75 Lawn Road, London, NW3 2XB
Application Ref. (2018/3114/P)

RESPONSE TO CONSULTEE COMMENTS

September 2018

Design and size of front/side extensions

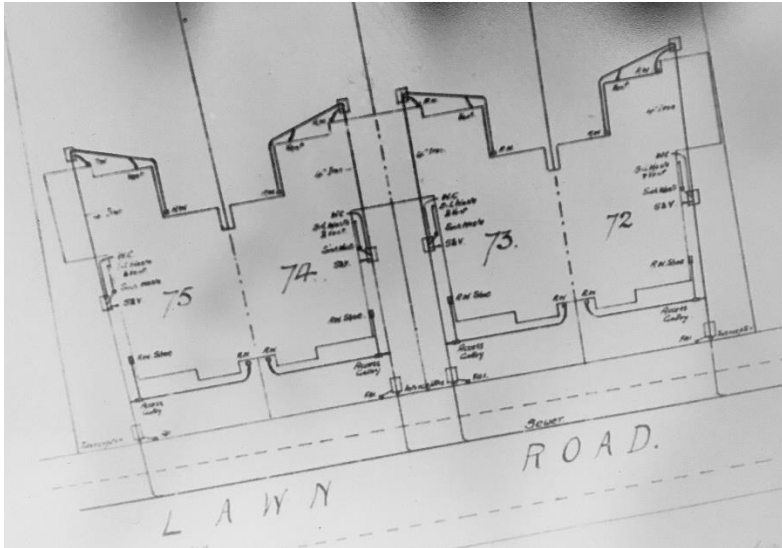
The Belsize Residents Association and a neighbour have objected to:

- a) The '*mansard roof on the side extension*', stating it, '*destroys the symmetry of the 2-story side extensions observed from the public highway*' and will '*create the only example along the row of 1920s Arts & Crafts style houses where the 1st floor side elements of two adjacent houses are not flush with each other (i.e. in the same vertical plane)*', and '*would look incongruous from the street*'.
- b) The '*front dormer*', as it '*would set a precedent*'
- c) the size of the 2m front first floor extension '*is not a modest extension*'

- 2.1. 75 Lawn Road was originally conceived as one of four dwellings in two linked pairs (No's.72 & 73 and 74 & 75 Lawn Road), with No. 76 being a detached house.

- 2.2. It is not entirely clear how it happened, but the design symmetry of these four houses diverged at some point in time, resulting in the current condition whereby No.75's existing two-storey garage block has a flat roof and sits further back from the road than the other garages within this grouping of terrace houses. This is in contrast to Nos. 72, 73 and 74 which have pitched tiled roofs. Consequently, the design symmetry of this group of properties has been eroded.
- 2.3. Number 75 and 76 weren't originally designed as a matching pair and therefore any symmetry between their two side elements is the result of later development.

- 2.4. The proposed development of No.75 Lawn Road seeks to enhance the legibility of this grouping of houses by reinstating a pitched roof design in traditional materials, thus improving the symmetry, balance and rhythm.
- 2.5. The reinstatement of a clay tiled pitched roof (*not a mansard as described by the Belsize Residents Association*), mirrors the characteristic roof form of the property grouping and will enhance the streetscape and broader conservation area.

Extract from section B-B showing extent of 2-storey pitched rear extension in relation to existing property outlines in purple.

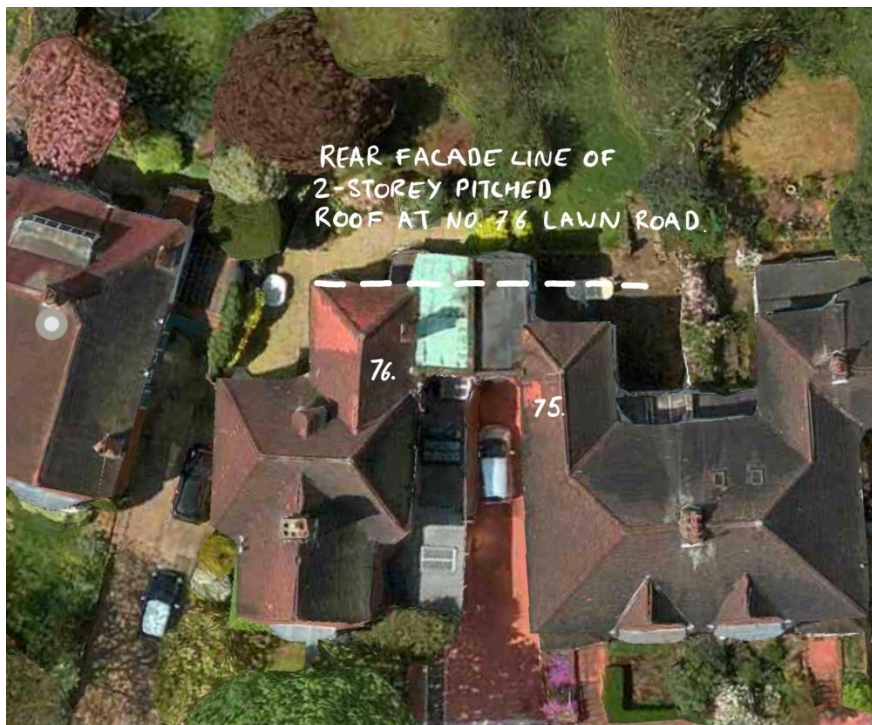
- ‘the proposals are too large and dominate the original house’

- The ‘bulk, scale and mass’ of the rear extension, stating, *‘it would not be subordinate to the existing dwelling, and would harm its character and the surrounding conservation area’.*

- 3.1. The proposed 2.19m two-storey rear extension is a continuation of the existing rear wing of the house, with matching ridge, eaves and pitch. As such, the proposal remains subservient to the main ‘host building’.

Computer Generated Image of front first floor window above garage at No.76 Lawn Road with window frame shown translucently. This image shows that the extension will not 'create a tunnel effect'.

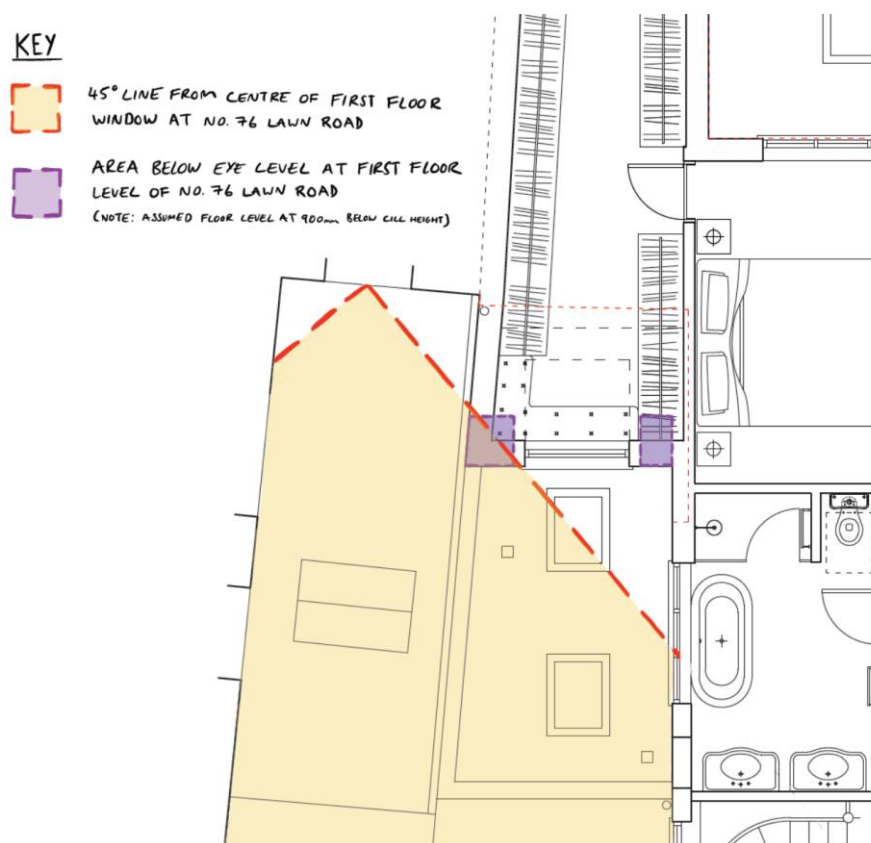
- being 'overbearing'
- creating a 'sense of enclosure', with the resident at No.76 adding that the new 2 metre projection 'will create a tunnel effect'.

4.3. Whilst there is no right to a view in planning terms, the view from this existing front window above the garage of No.76 remains predominantly unchanged as the front extension only partially obscures the view of No. 75 Lawn Road's flank wall and first floor windows.

The best views from No.76's first floor front window (above the garage) aren't of No.75, instead they are across Lawn Road towards the foliage and Italianate style town houses opposite. This aspect will remain unaffected by the development.

Whilst the proposed side extension will be visible from No.76's first floor bedroom window, this impact is considered minimal as it will only obstruct views of the flank wall of No.75 Lawn Road (see below visualisation).

Proposed first floor plan showing 45-degree visibility zone from No. 74's ground floor rear living room window

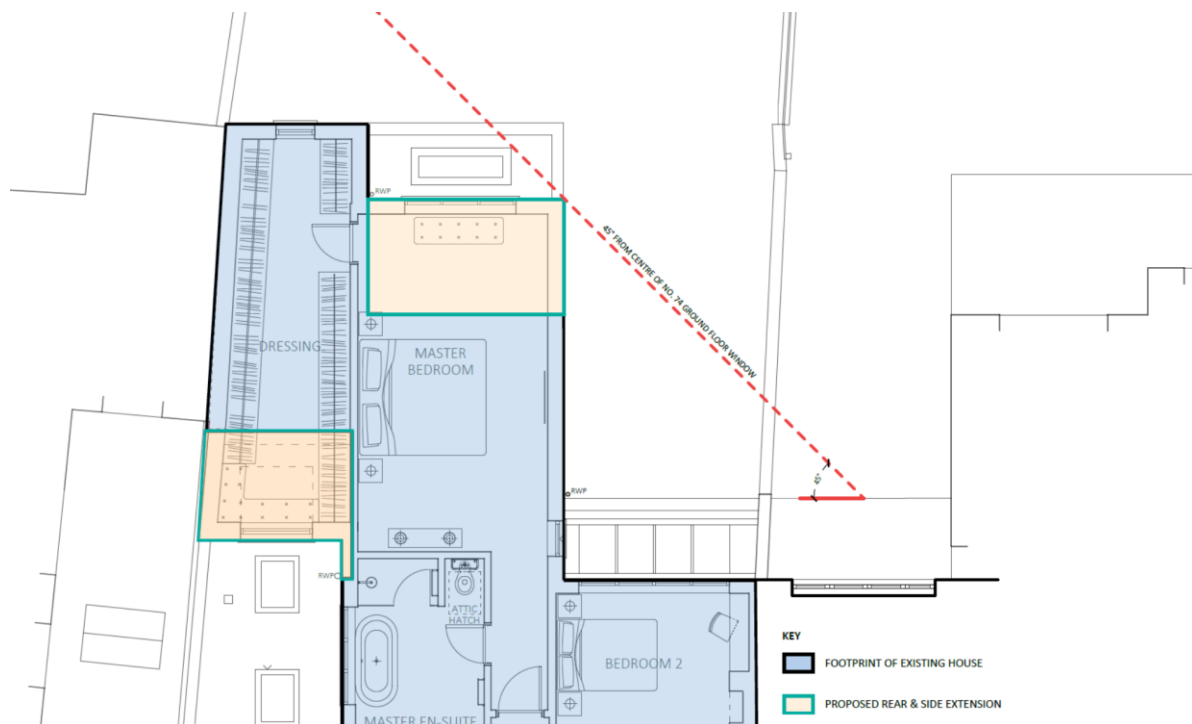
- the rear extension's 'mass and position close to the boundary would have a detrimental effect on the amenities of 74 Lawn Road.'

- the '2 storey rear extension will create an increased sense of enclosure' and be 'overbearing for no.74'

4.7. Following the refusal of the two-storey infill extension under application 2017/6726/P, the proposed rear extension at first floor has been reduced to a modest 2.19m extension. Based upon the rule of thumb amenity test applied within the delegated report (outlined above) the proposed rear first floor extension will no longer intrude into the '45 degree visibility zone'. It is therefore considered that the rear extension will have no impact upon No.74's amenity in terms of sense of enclosure, overbearing and outlook.
